CITY OF CHARLOTTESVILLE
"A World Class City"

RE: Certificate of Appropriateness Application

BAR 16-01-04

New construction-Massing

WEST MAIN STREET ELEVATION

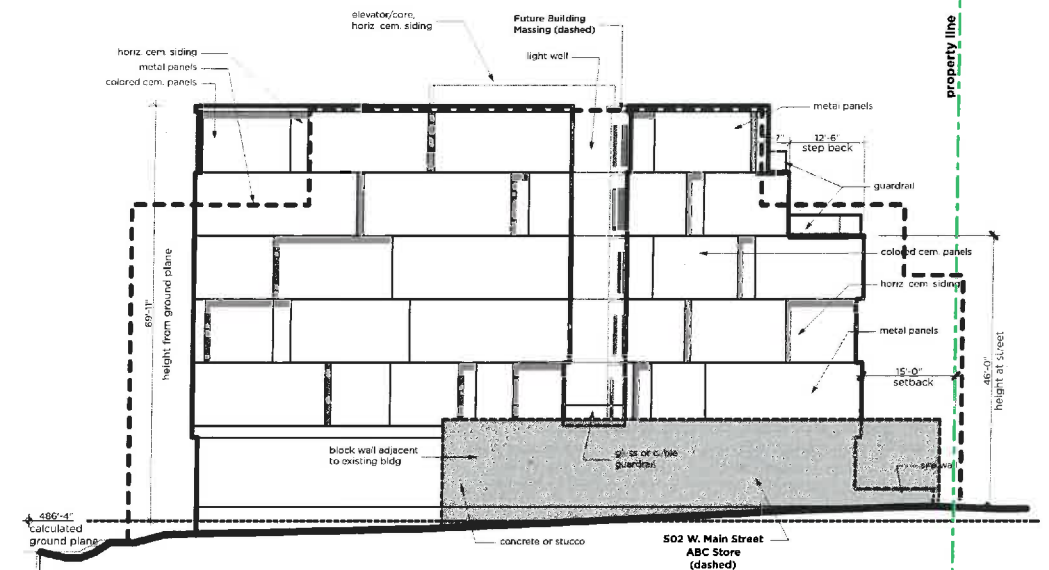
On the West Main Street frontage there is a minimum required 15' building setback. **The proposed 3-4 story streetwall is 35'- 3" and 47' tall. There is an additional stepback after the fifth floor.** The building is built to the property lines on the east, west and south sides. **The east and west facades will be articulated with changes in materials and relief, rather than windows.**

In staff opinion, the massing and siting have been improved by lowering the height, and adding space between the historic buildings and the new construction. A remaining issue is the treatment of the end walls. While it is impossible to know when the abutting properties may develop, it is common in an urban setting to have end walls without windows. The BAR is being asked to approve the massing. The BAR may also provide comments regarding the façade treatments, materials and site design.

- the height of the building has been reduced by one entire floor.
- the portion of the building on WMS, east of the Blue Moon, now has 2 step backs (as opposed to 1 in the previous submission) in order to reduce the mass of that frontispiece. In addition, the topmost step back suggests a change of material to visually recede even more, and a rooftop terrace above the top floor has been eliminated.
